Los Alamos National Laboratory	
Title: 64 ch Strip Detector Motherboard	
SCHEMATIC	
Size B	Date Originated: 2 Oct 2000
	Last Revised: 9 Nov 2000
LANL DWG #: 135Y299070	Approved By: K. Kwaitkowsk
Engr: G. Hart	Drawn by: G. Hart
Filename: 135Y299070.sch	Sheet 1 of 1

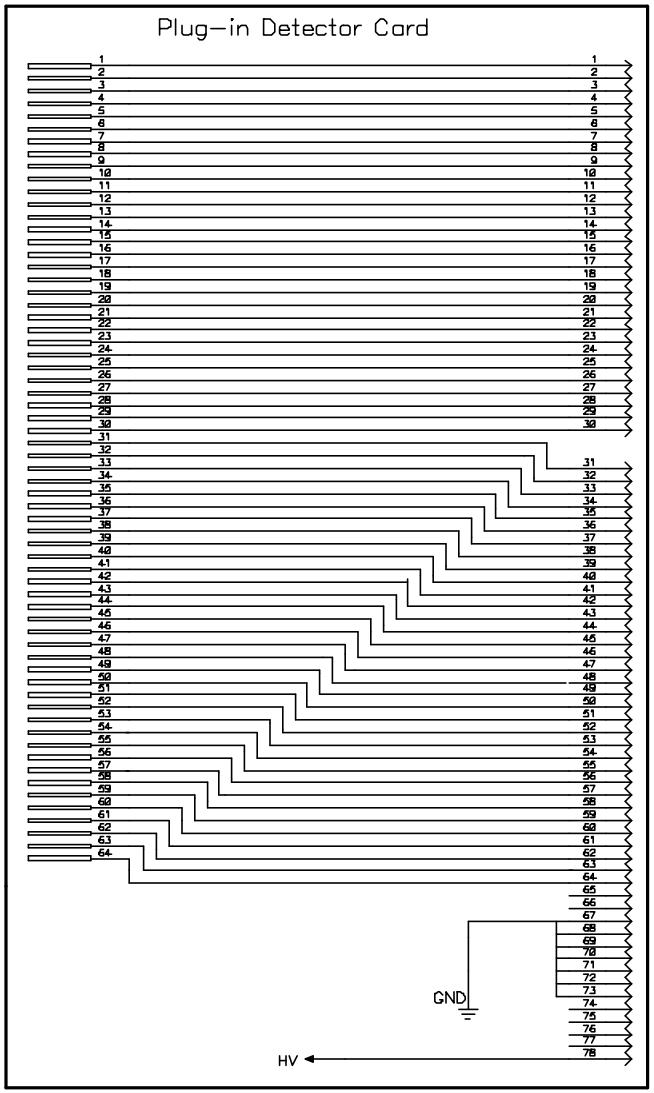
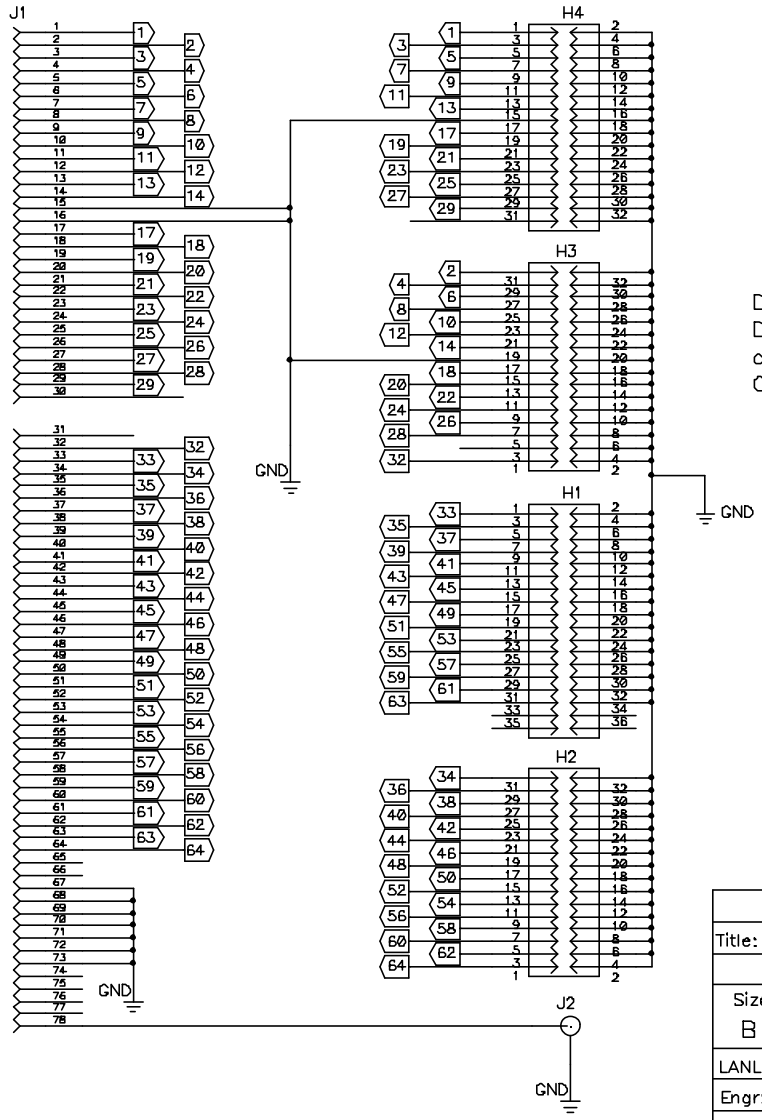
Due to error in connector design
Detector strips and mating readout
channels 15 & 16 are grounded.
Channels 31 & 32 are open
